Access Compliance Report Public Rights-of-Way (Curb Ramps)

Intersection ID: 10918 Main Street: MATHESON AV **Cross Street: HOLT ST** Location: Initial Pass/Fail: Fail **Overall Compliance: No** ADA ID: B85EA869F2CA Ramp Type: PerpDiag

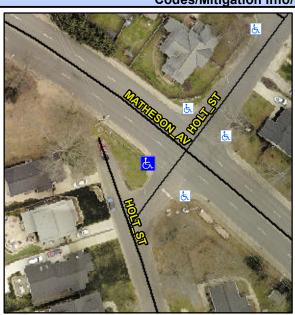
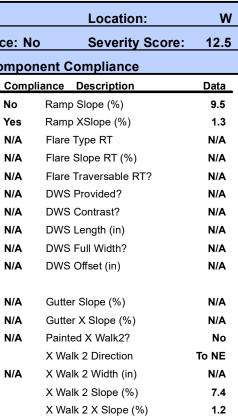
Not Found, R304.2.2

Remove & Replace Curb Ramp With Two New Directional Ramps or Equivalent.
